Hartland Township Planning Commission Meeting Agenda Memorandum

Subject: Site Plan with Special Land Use Application #26-007 (Kroger Automobile Fueling and Convenience Station)

Date: July 29, 2026

Re: Kroger Gas Station – Site Plan Review
SDA Review No. HL25-101

A0.0

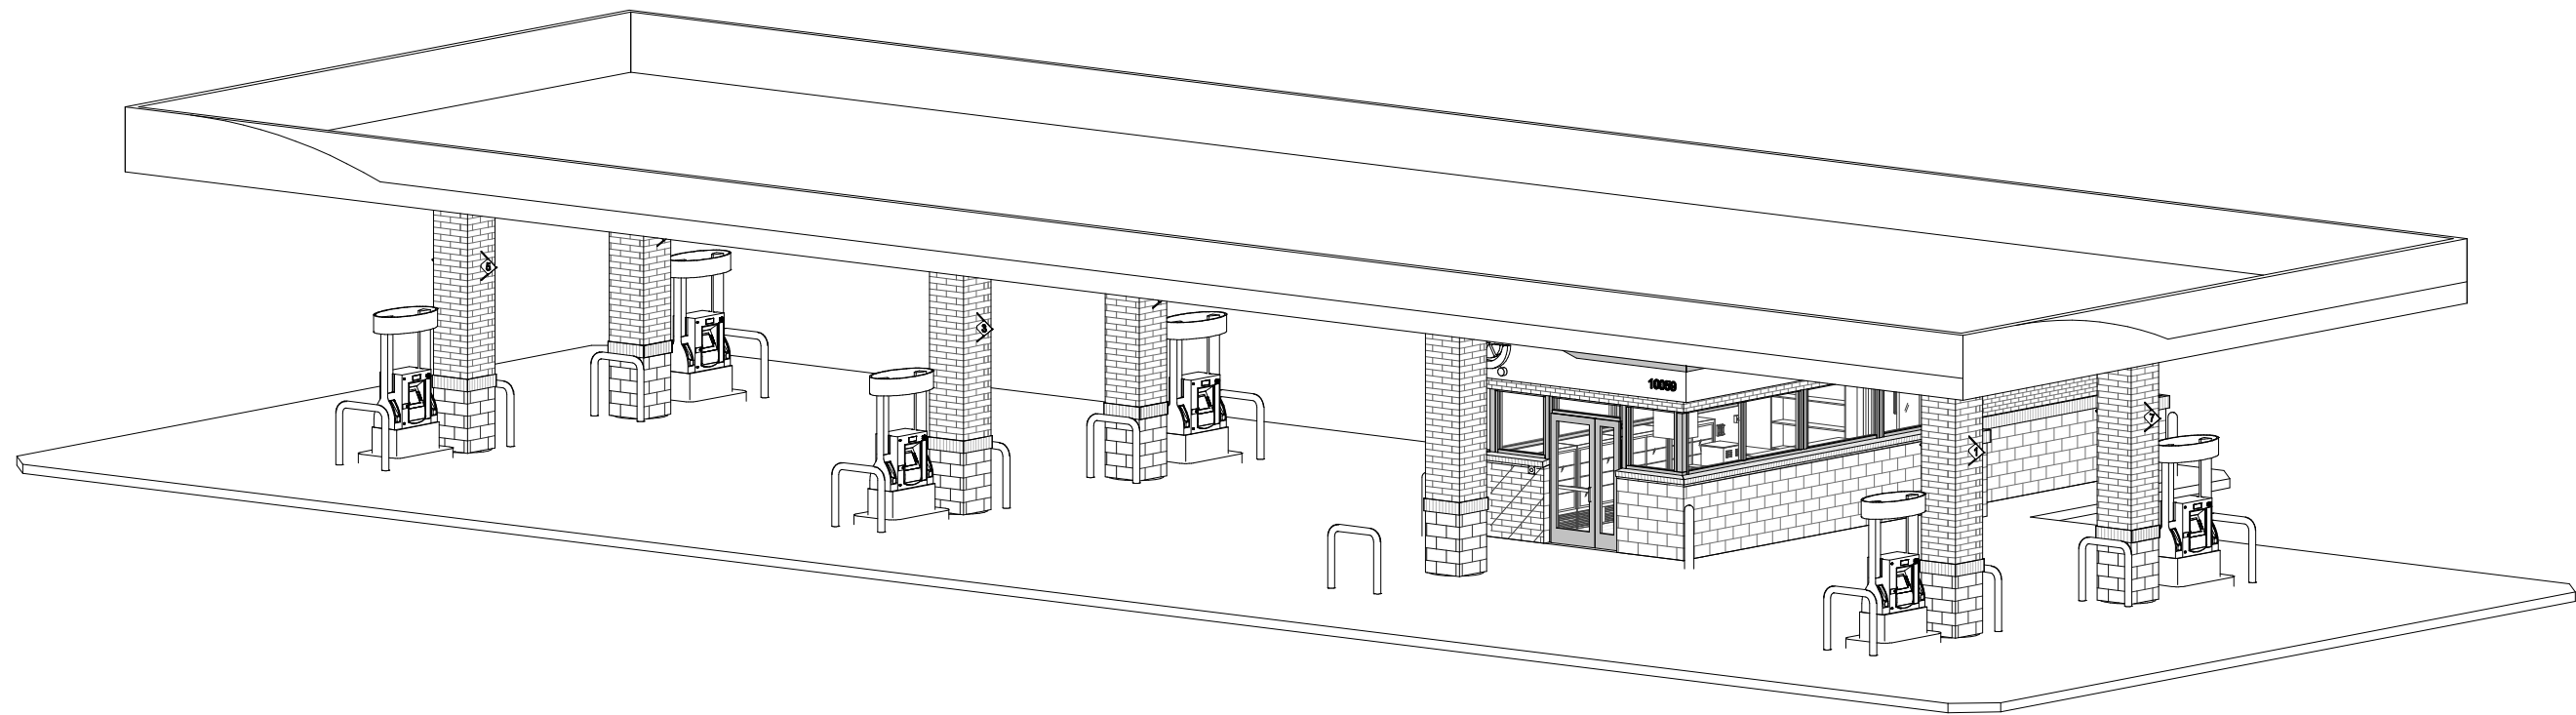
- Meets Requirement? – TBD
- Comment – The Planning Commission to determine if the proposed façade material percentages are acceptable as listed.

- The façade materials listed on this sheet for the two (2) kiosk wing walls/screen walls shall match the façade materials stated on Sheet A0.0 (Exterior Color Elevations).
- The note “Screen walls to shield outdoor equipment” on the west side of the building, shall be removed and replaced with a note that states “Outdoor Storage Area” (for the area between the two (2) screen walls).

PROPOSED EQUIPMENT PLAN

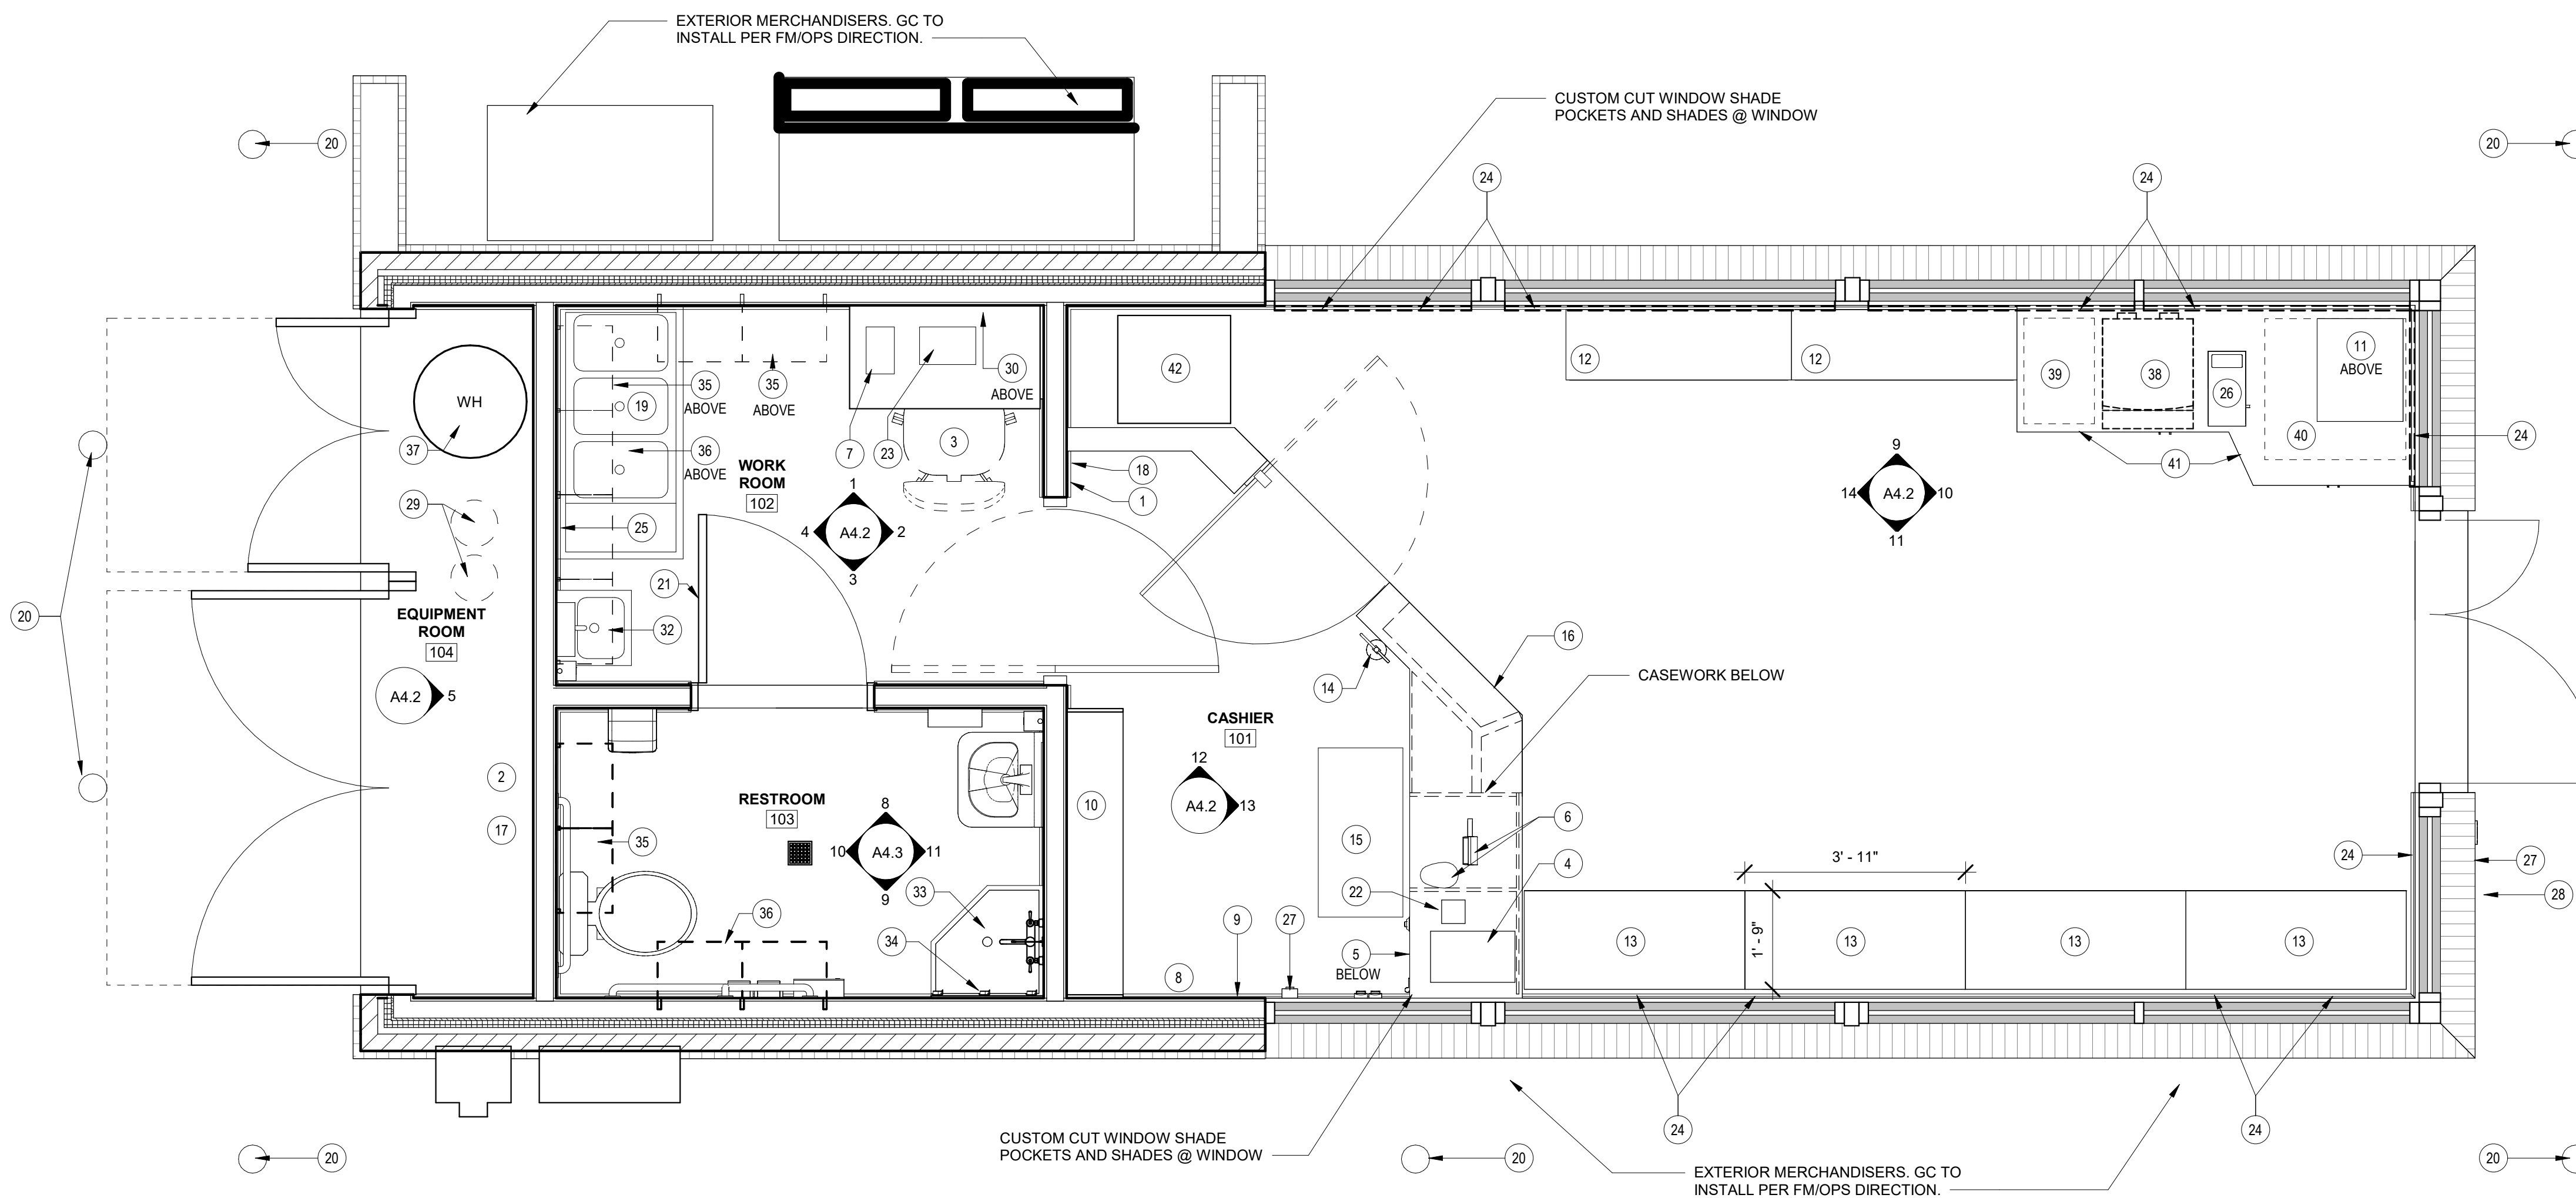
Per Sheet C1.20 an ice merchandiser and spill cabinet are shown in the outdoor storage area. Sheet A1.1 (Floor plan of the building), a note states exterior merchandisers are to be installed in the storage area, however the specifics on the types of products are not provided. The outdoor storage area should be labeled as such and be consistent on all sheets. Specific merchandiser units, cabinets with items for sale, or other items should not be specified on the plans. The understanding is that one (1) outdoor storage area is permitted on the west side of the building, between the two (2) screen walls, as shown on the plans. Specific merchandise/products within the outdoor storage area do not need to be identified on the plans. All products must be placed within the designated outdoor storage area.

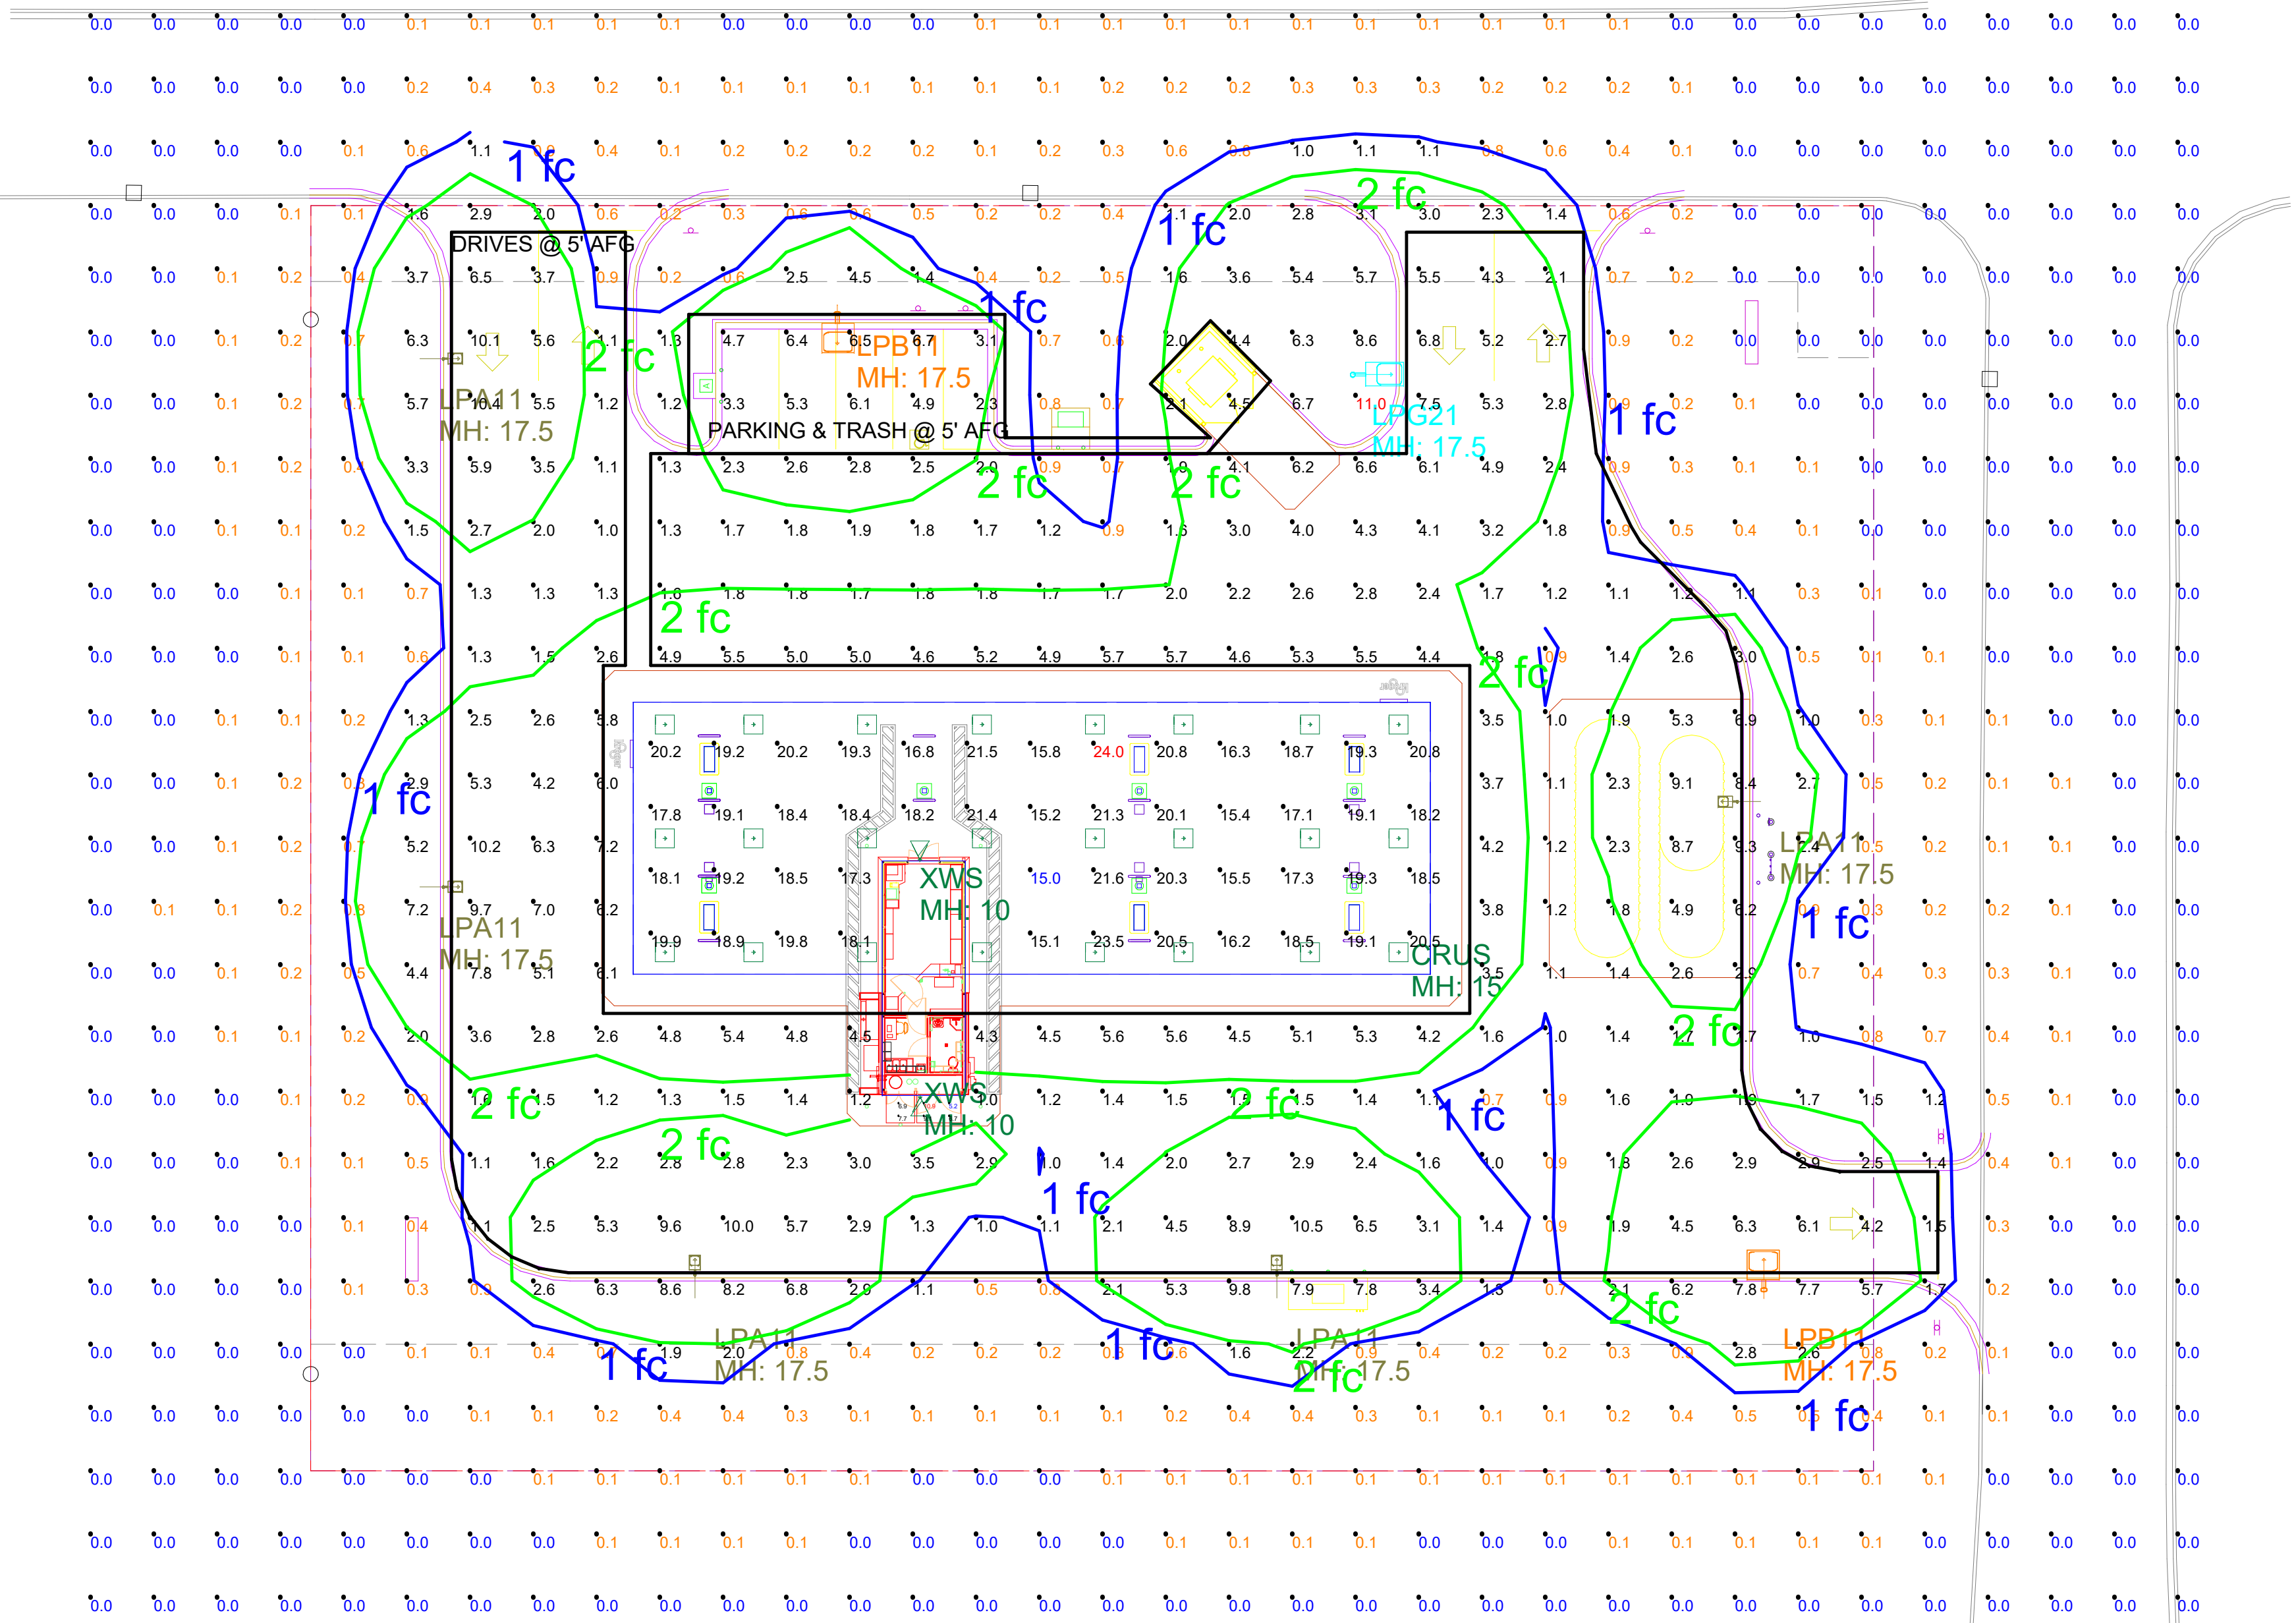
A photometric plan has been provided and details will be discussed within the context of the site plan review. The average illumination level allowed under a fuel island canopy is 20 footcandles. The average illumination level under the fuel island canopy is shown to be 18.82 footcandles.

- Proposed – photometric plan indicates average of 4.66 fc in the parking area and trash; average of 7.75 fc at building entrance; average of 3.49 fc at driveways; and average of 18.82 fc under the fuel island canopy. Footcandle value less than 10 fc throughout the site (except under fuel canopy). Housing of light fixtures under the fuel island canopy has a slim profile design and nearly flush with canopy ceiling.

- Comment – The photometric plan should be revised to comply on the Construction Plan set.
